HISTORIC DISTRICT COMMISSION

CERTIFICATE OF APPROPRIATENESS

Application Number: HDC2025-00082

Project Address: 470 Brainard Street, Detroit, MI

INTERIOR + EXTERIOR ELEVATIONS - NEW WORK

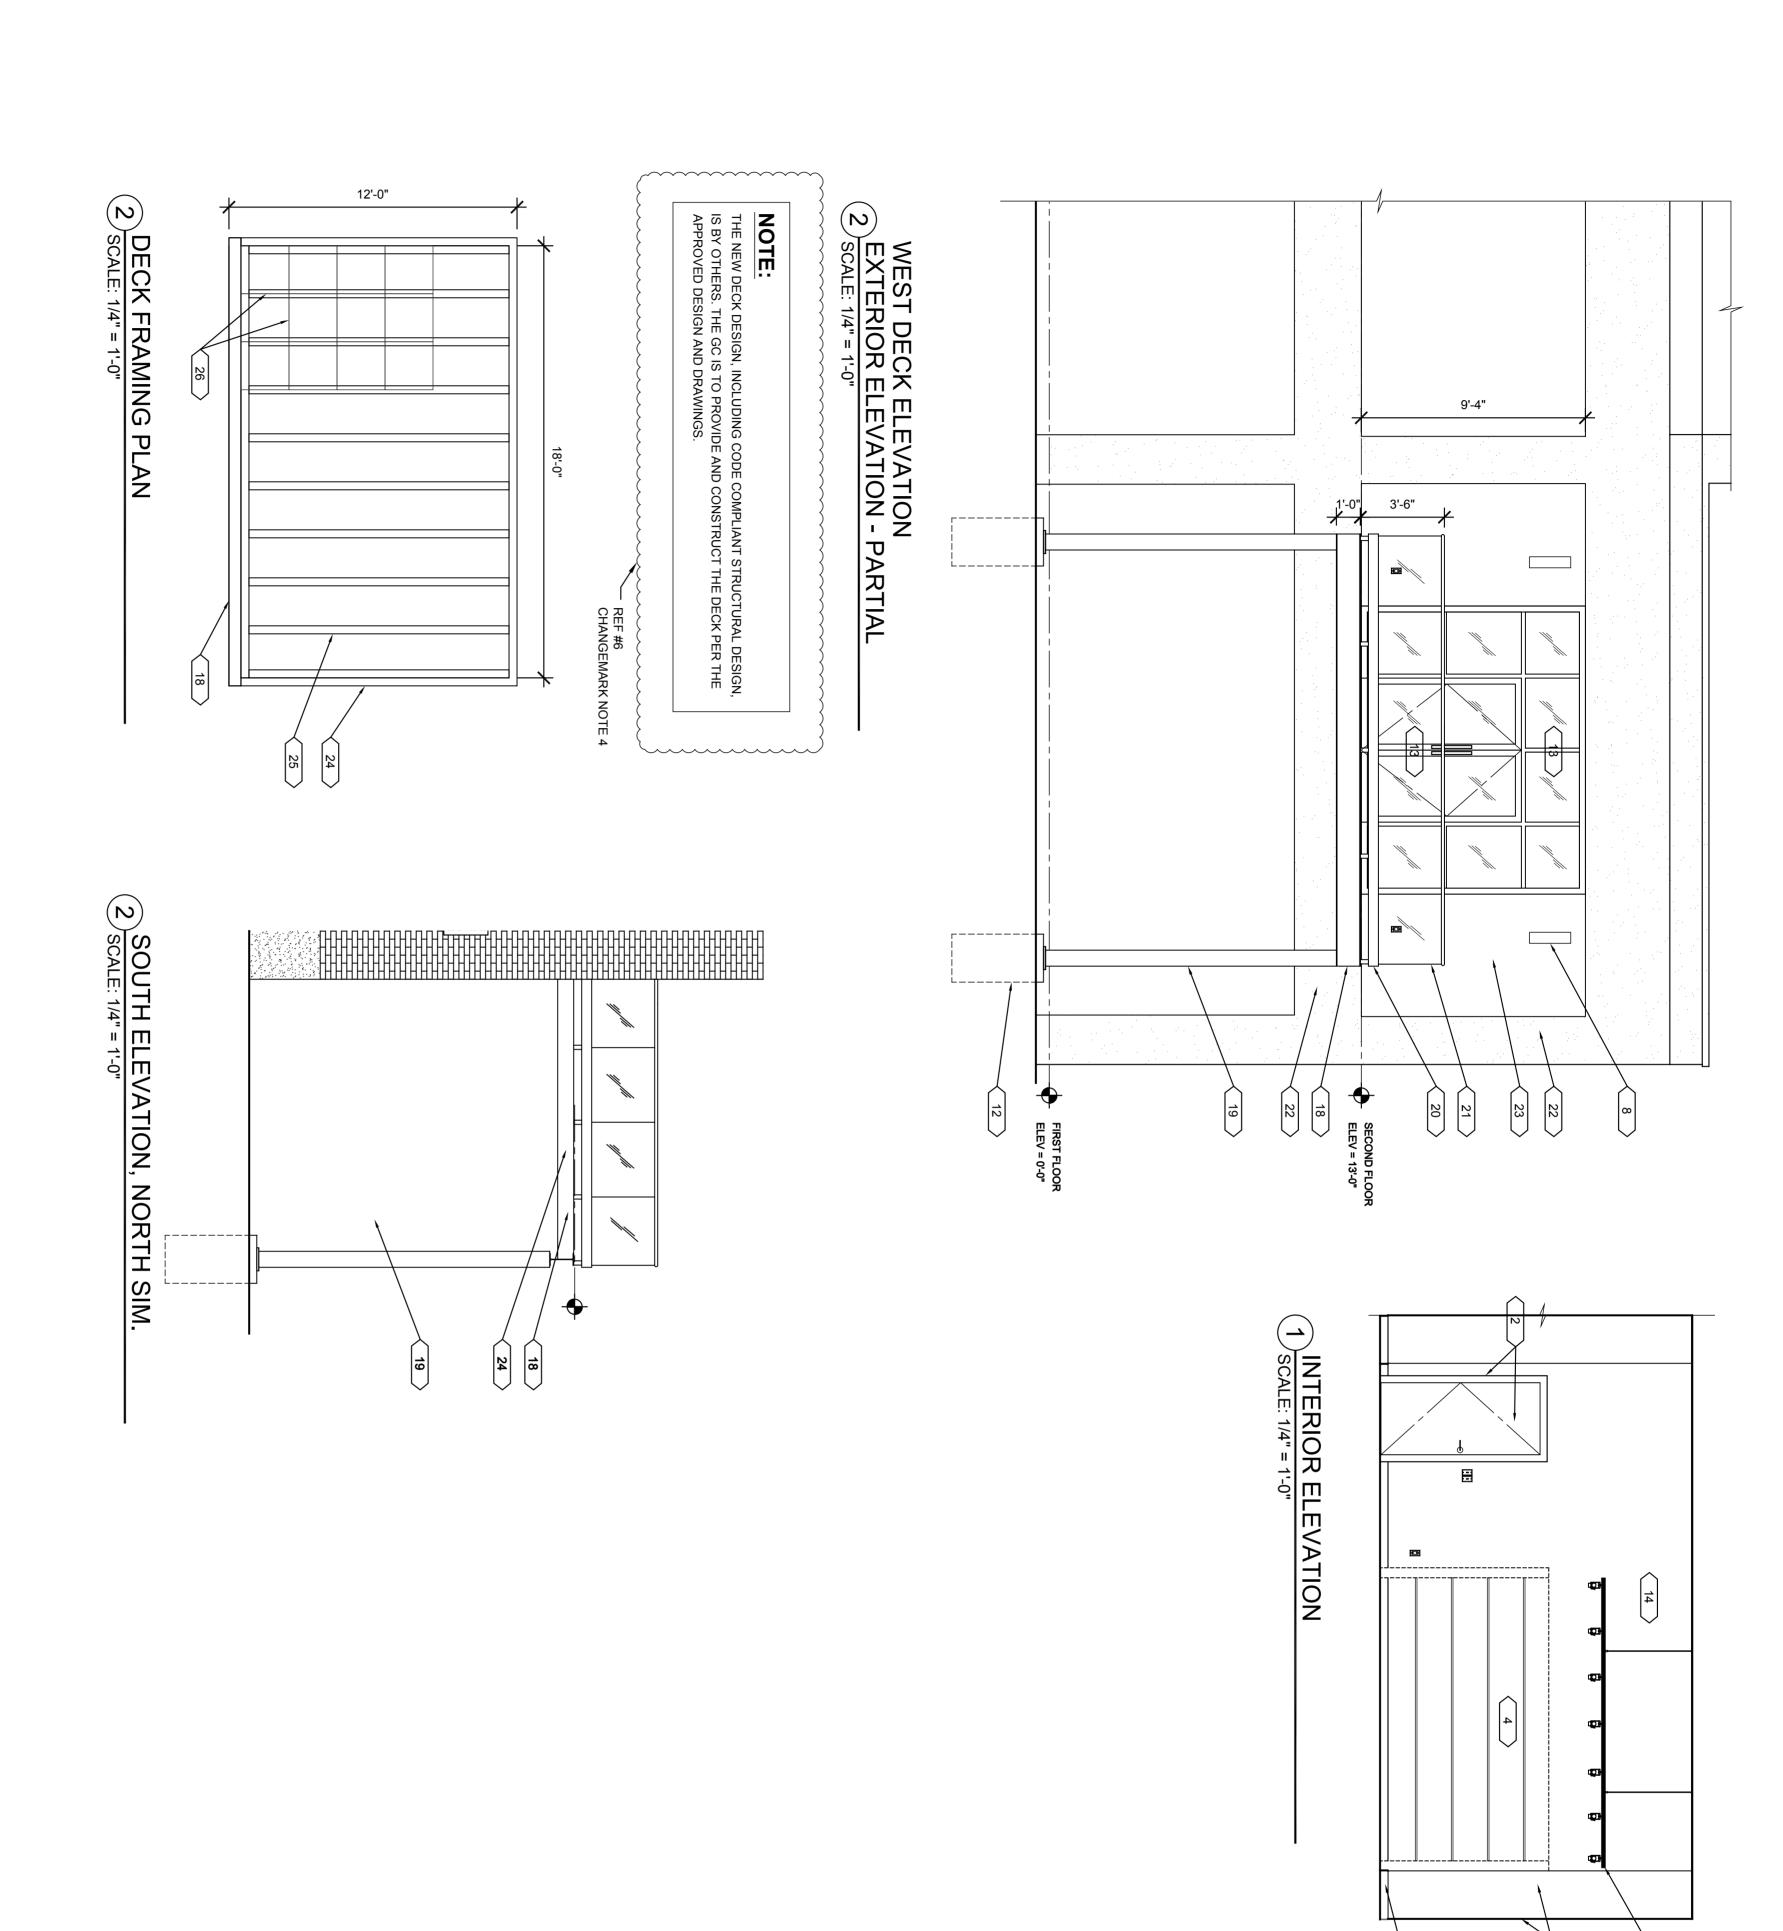
This application is not complete. Please provide dimensioned plan for the new side porch which calls out materials. Also, note that this case will need to be reviewed by the Commission at a meeting. The next meeting is scheduled for 4/9/2025. In order for the case to be included on that agenda, we will need the outstanding info re: the side porch on 3/24/2025.

sponse Date: 03/20/2025	SE .		
eet A7.00 has new elevation and e elevation sheet, A7.00, is inclu
